ATTACHMENT A

KENWOOD COMMUNITY & SENIOR CENTER ATTACHEMENT A

ADDENDUM #1 – REVISED DRAWINGS

S2.2
BEATTY PALMER ARCHITECTS

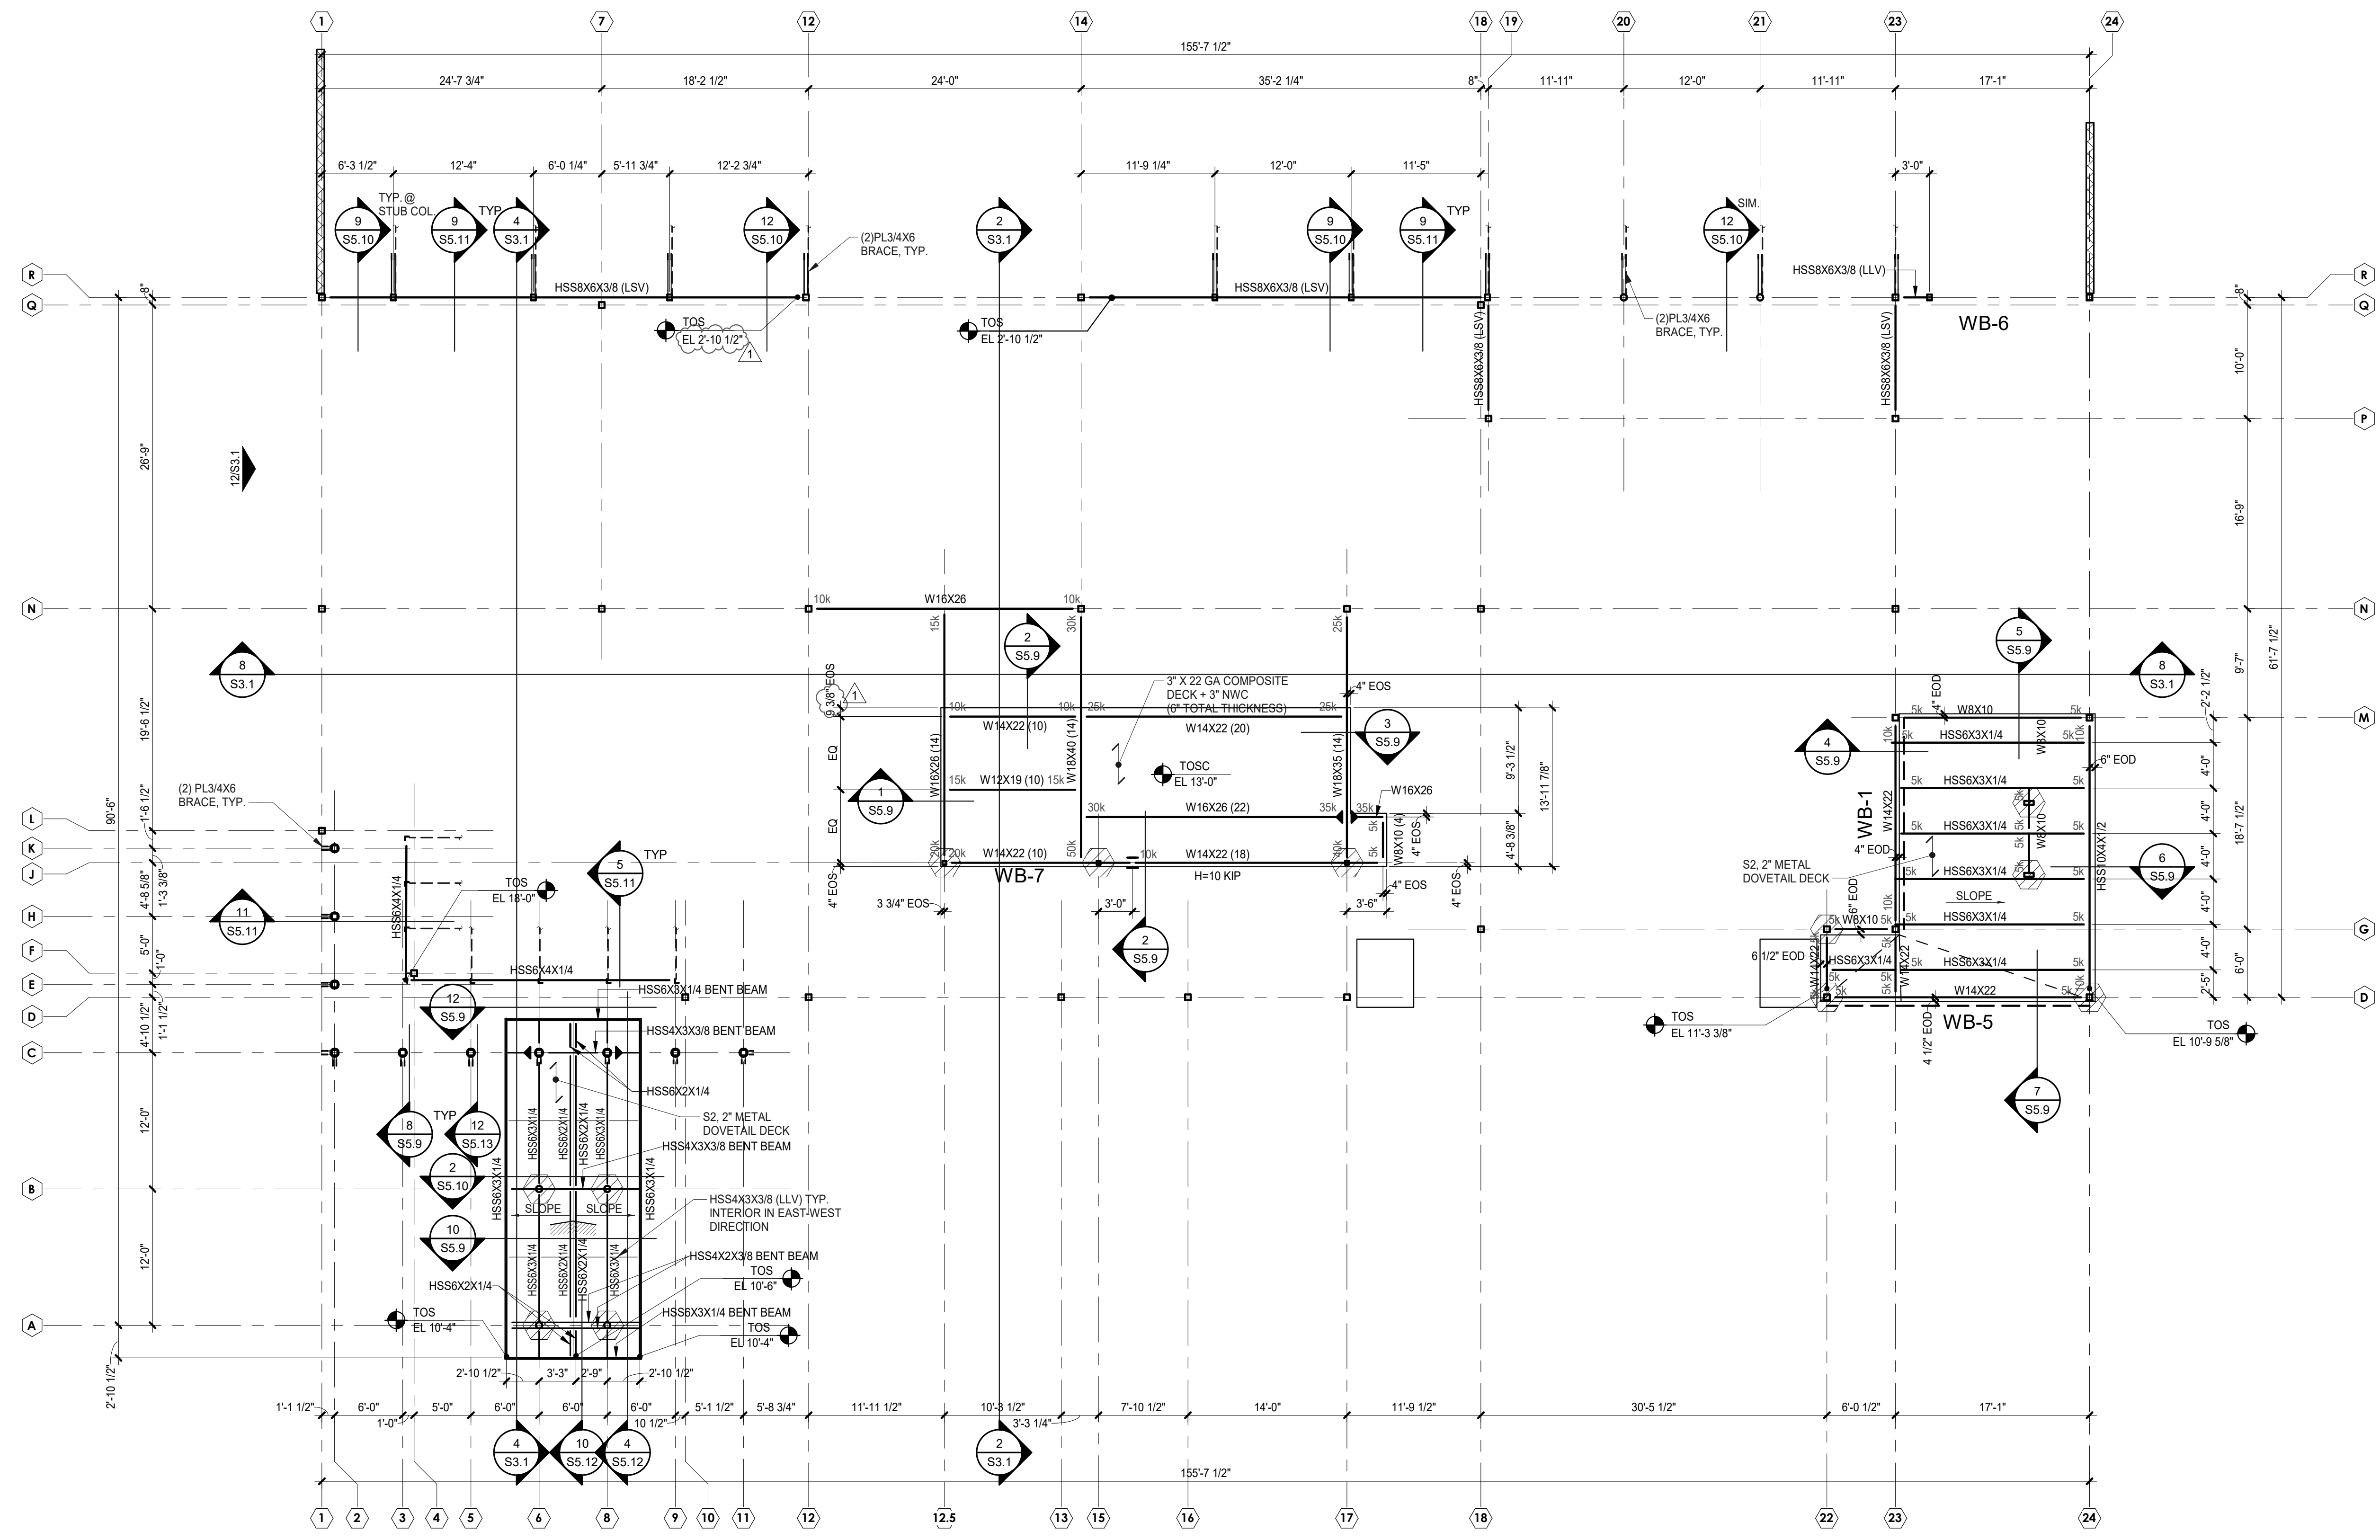
At the owner's direction, hinges and a steel angle with padlock hasp have been added to the front (2) areaways to secure crawlspace access. (30 Areaways at the back of the facility within the fenced yard are to be equipped with (2) saddle clips each. Refer to attached revised sheets A3.2 & S2.2.

Stoops have been added to doors opening onto the sidewalk, refer to attached revised sheet S2.2.

- 22 BINGO BOARD LOCATION / POWER AND DATA ROUGH IN PER ELECTRICAL DRAWINGS
 - 23 AREA WAY / REFER TO DETAILS ON SHEET A3.2. (2) SADDLE CLIPS EACH FOR (3) REAR LOCATIONS, HINGES AND PADLOCK HASP FOR (2) FRONT LOCATIONS

S3.1

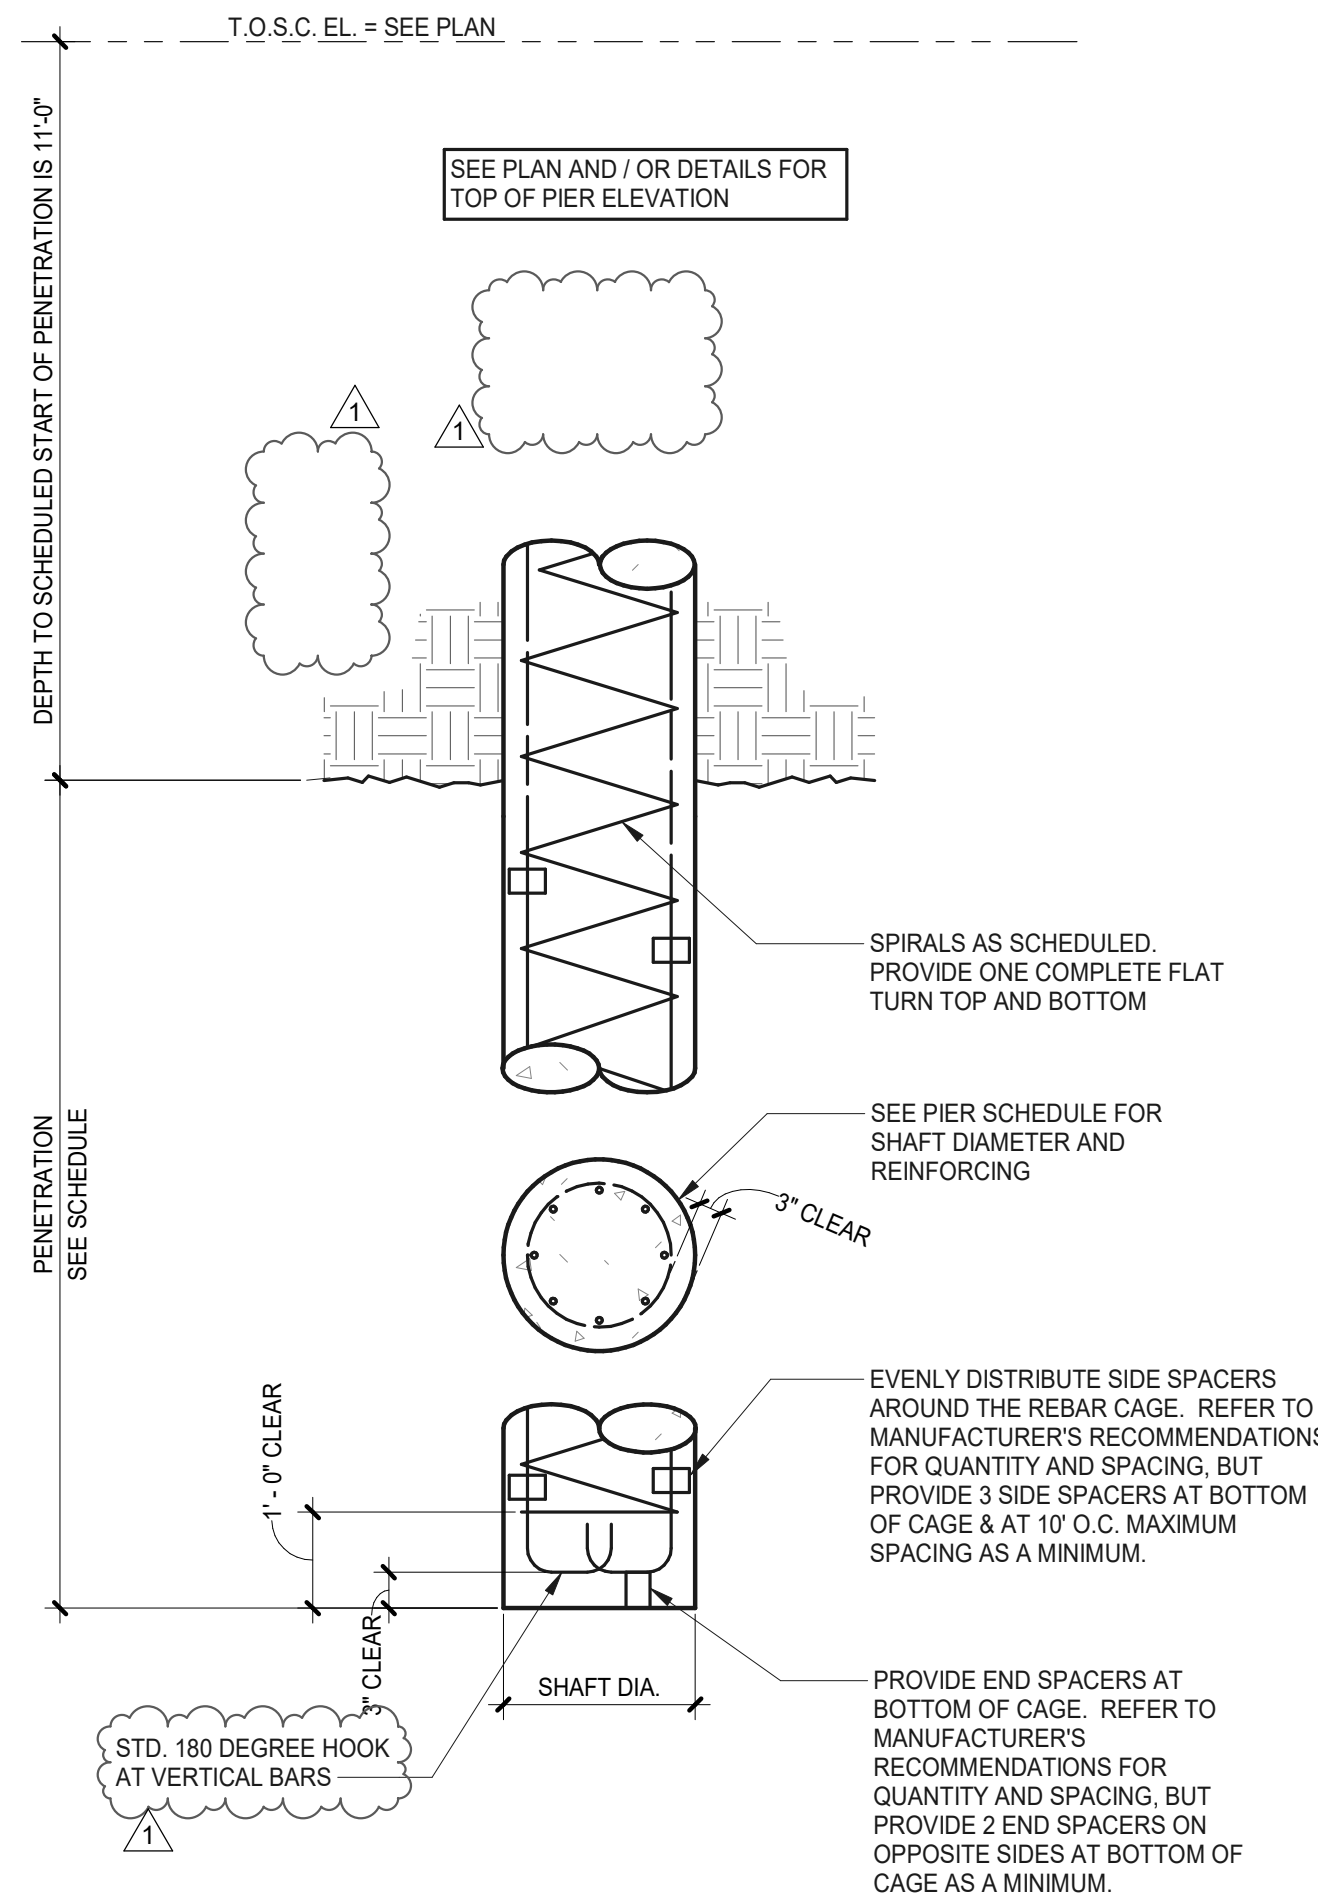
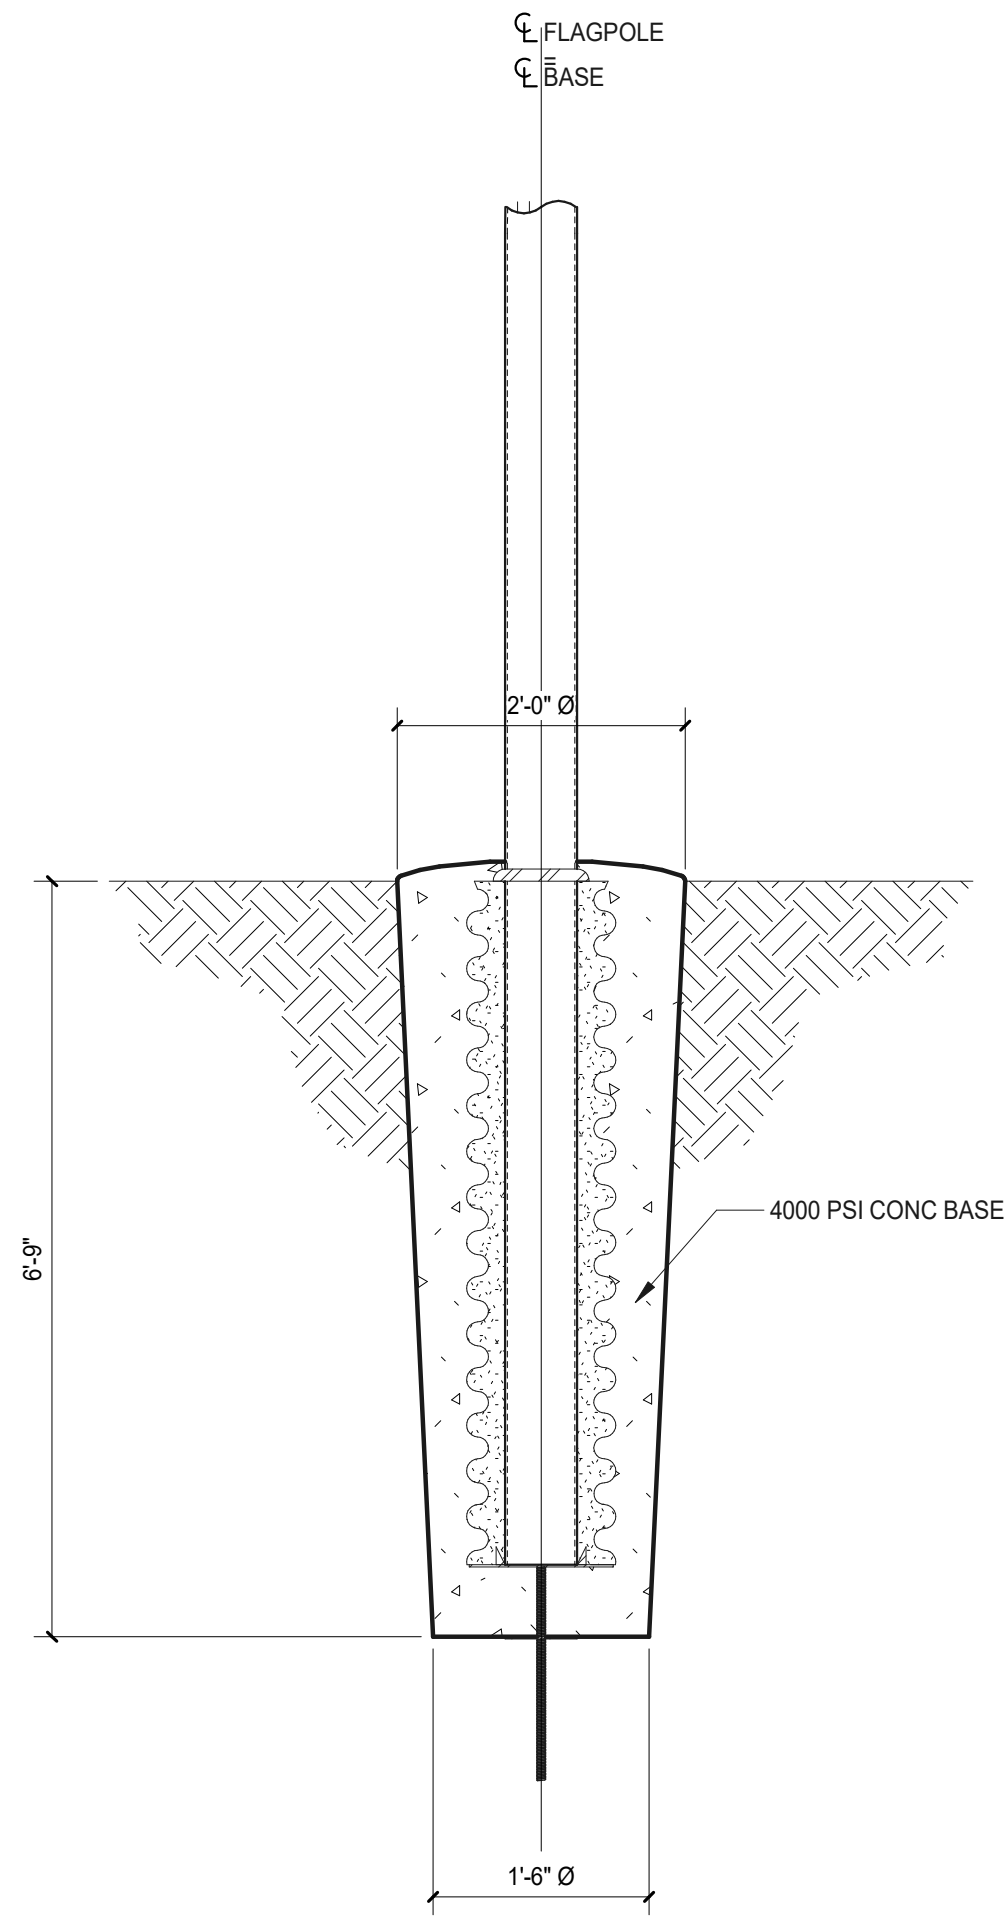
An additional Elevation has been provided to show bottom of grade beam and bottom of brick, refer to attached revised sheet S3.1.
